CV Input Scaling

Power Sections

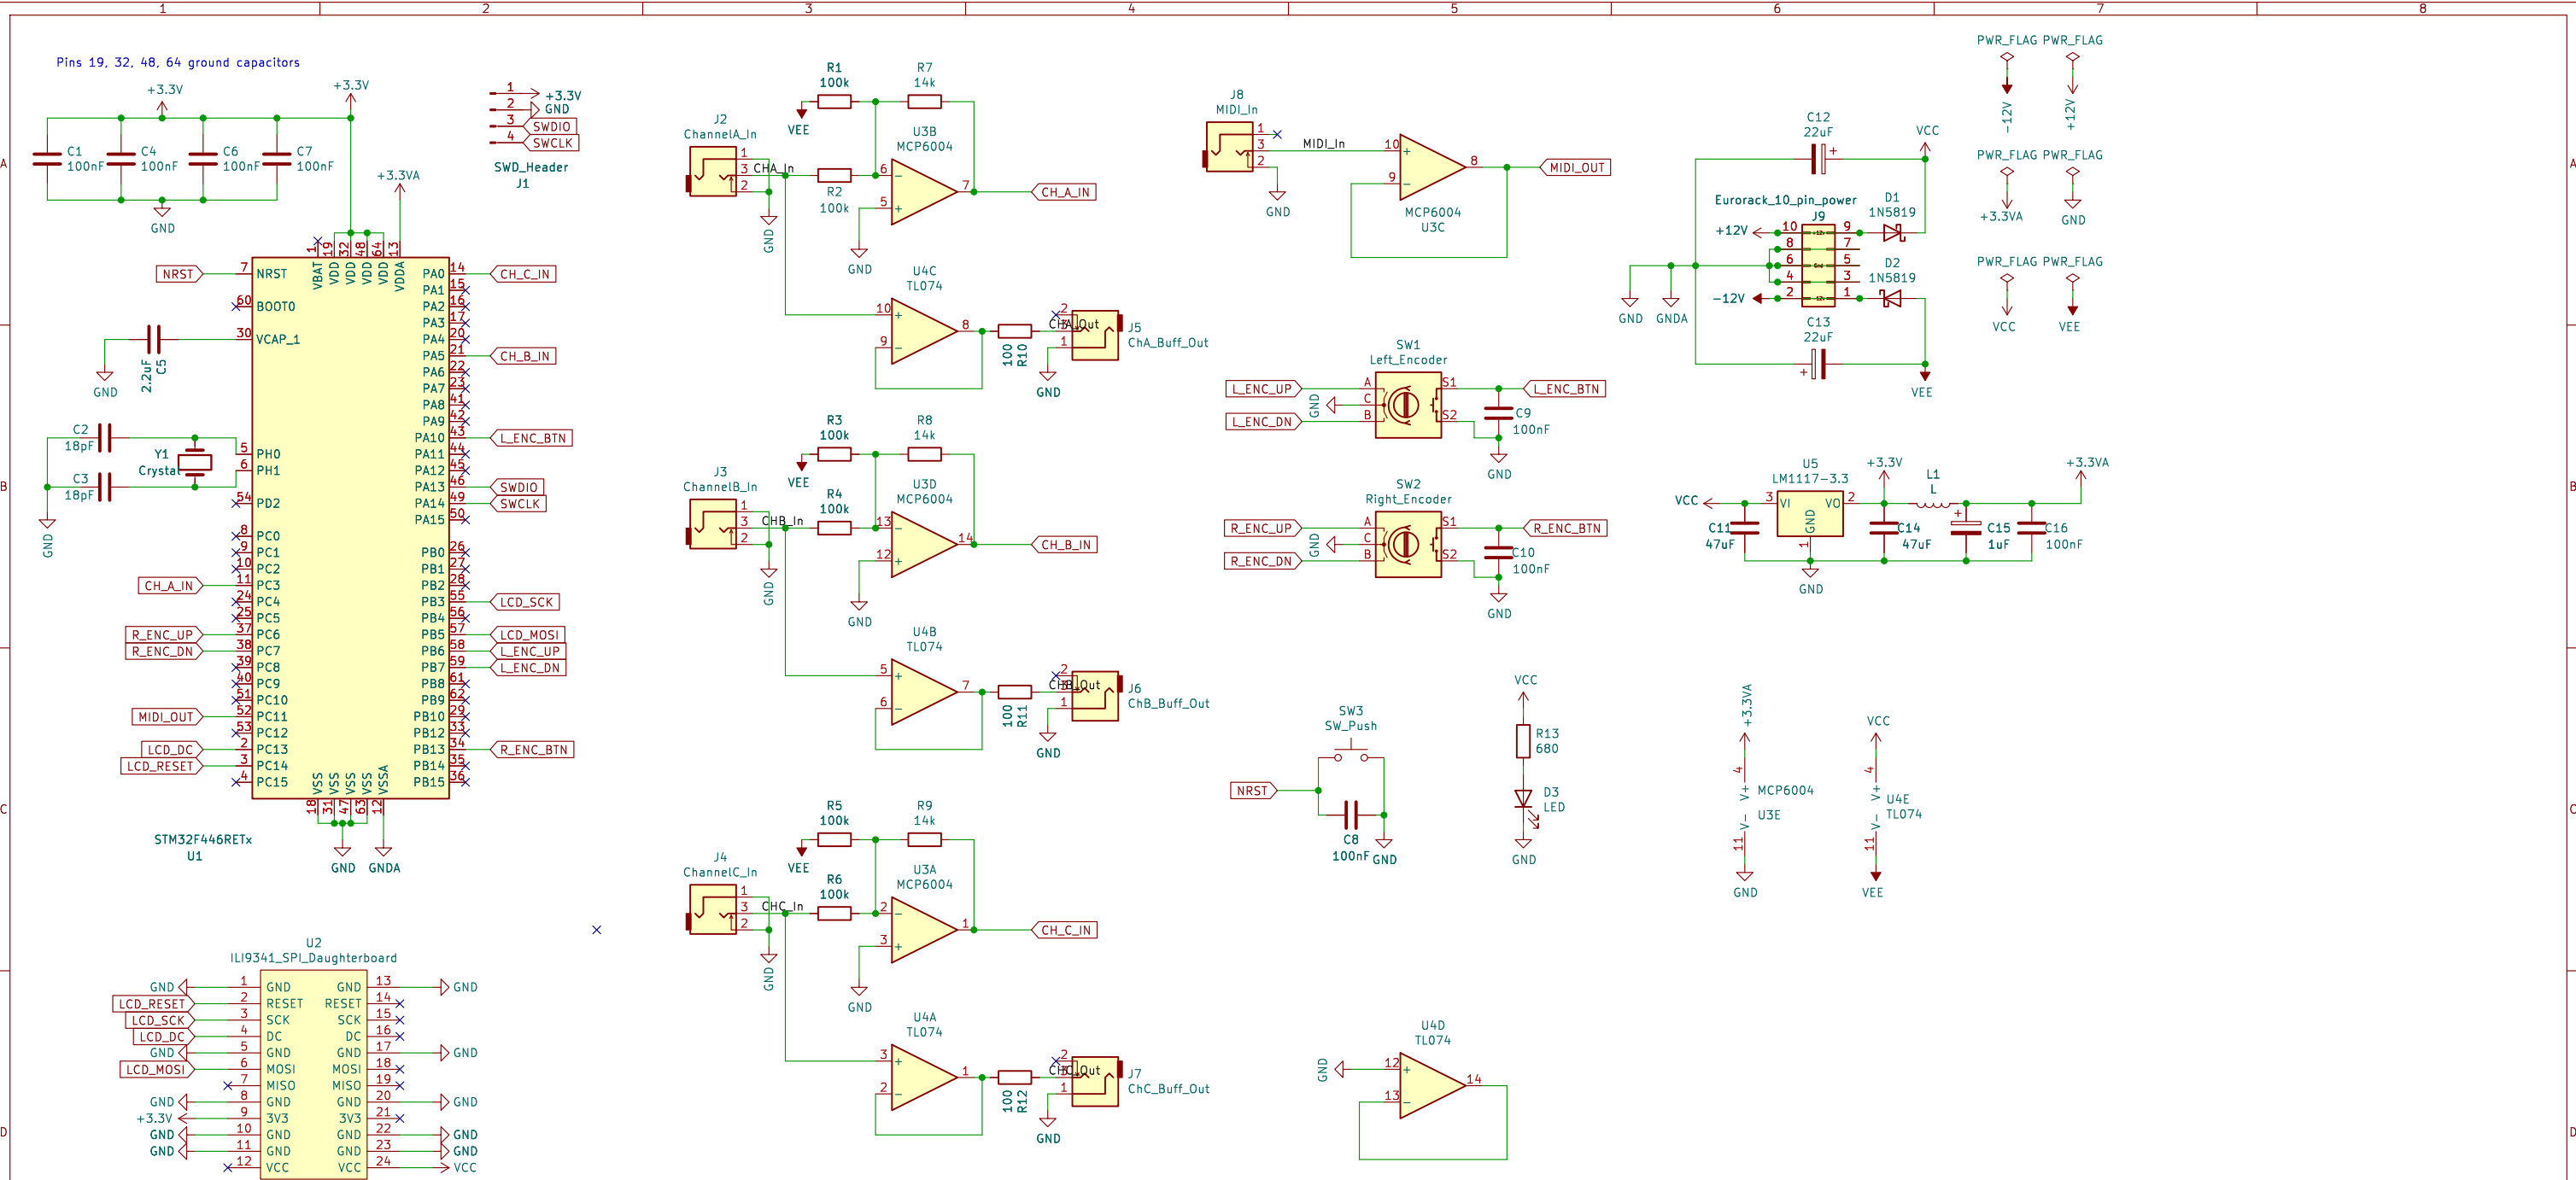
Input Scaling: 15k resistor limits maximum negative input to 8.5V
12k resistor -12V -> 2.88V
?? Try 13k

- Fixes for next version:
- Pull-down on BOOT0 pin
 - Move daughterboard components to main board
 - MIDI in using TRS
 - Opto-coupler on MIDI
 - MIDI buffered through (x2?)
 - Buffered mults on ABC channels
 - Remove cap on encoder button
 - Decoupling caps on MCU and Op-amps
 - R2 on daughterboard increased to 1.5k to improve backlight brightness?
 - Oscillator load capacitors
